DEPARTMENT OF PERMITTING SERVICES

Inspection/ Investigation Notes

| DPS Case # | 420393 |
| | TRAIL OF TERROR & 29 SPECIAL AMUSEMENT BUILDINGS |

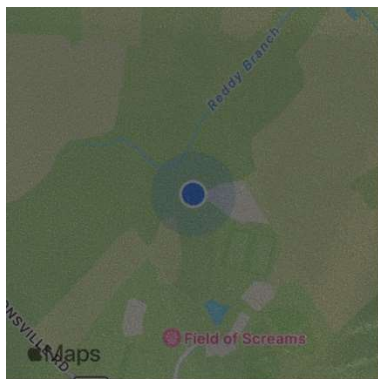
- The buildings and structures are not constructed in accordance with IBC Chapter 23. Pressure treated wood is required to be installed since the buildings do not have an approved vapor barrier. Non-pressure treated lumber is in direct contact with the

ground, which is prohibited. The construction of this buildings is not compliant with the building code and does not conform to conventional framing methods, IBC, and NDS.

Lodge

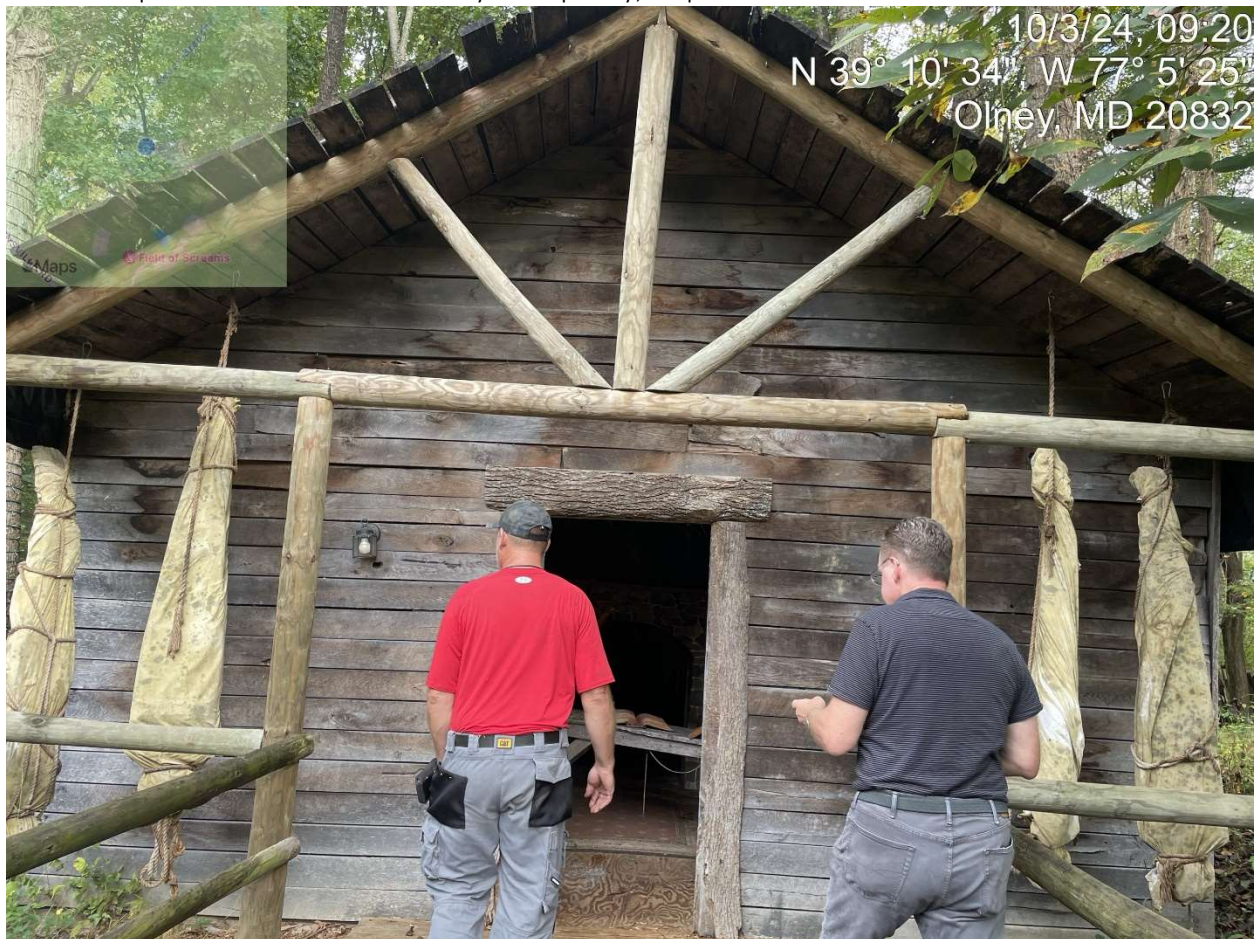
- The circulation path and means of egress do not have the required headroom throughout the space; 80" is required as IBC section 1003.3.1. The fireplace obstruction in the walking path is about 5 ft above the finished floor.
- This building does not have an adequate foundation, as required by IBC Chapter 18. 2x4 non-pressure treated lumber is being used and the floor joist spacing does not comply with IBC Chapter 23, therefore is unlikely it complies with the structural Live Load requirements for an Assembly Occupancy, as per IBC section 1607.

Stairs leading aware from Leatherface

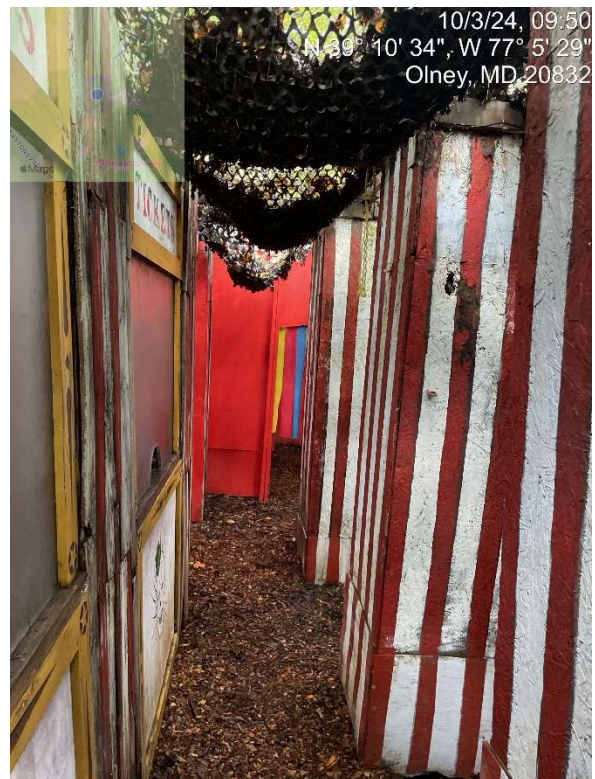
- Guardrails are provided that are 32" off the stair nosing. This is required to be 42" as per IBC section 1015.
- Must provide graspable handrails on both sides, while maintaining the minimum egress width as per IBC Chapter 10 and NFPA 101 Chapter 7.

Vortex

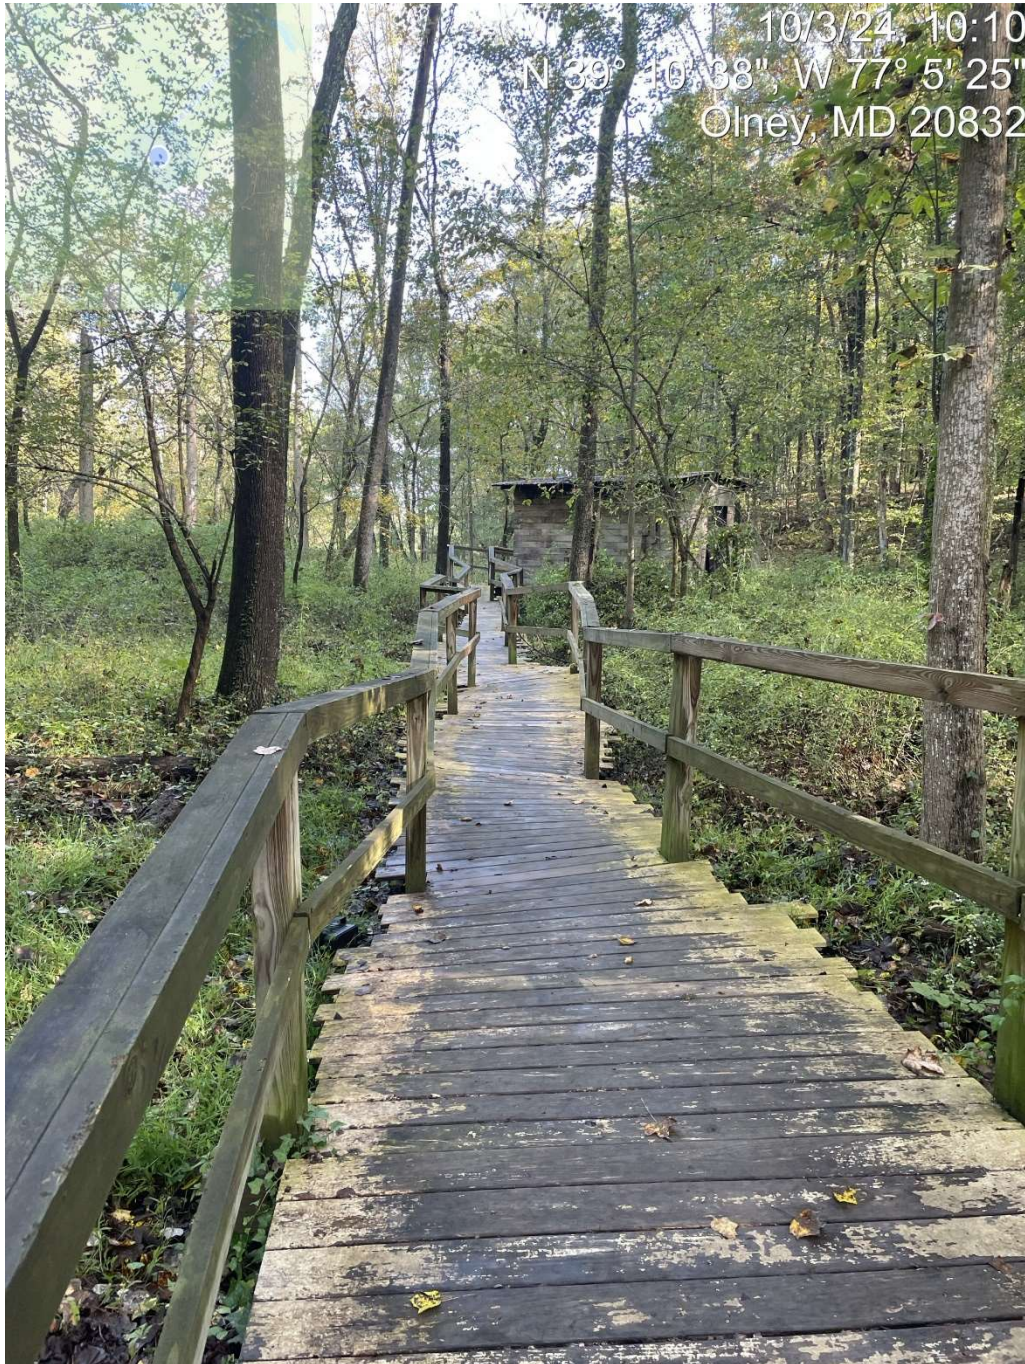
- Must provide handrails and guardrails for entry ramp
- The entry ramp exceeds 8.3% maximum slope as per IBC sections 1001.3 and 1011, as amended by Montgomery County.
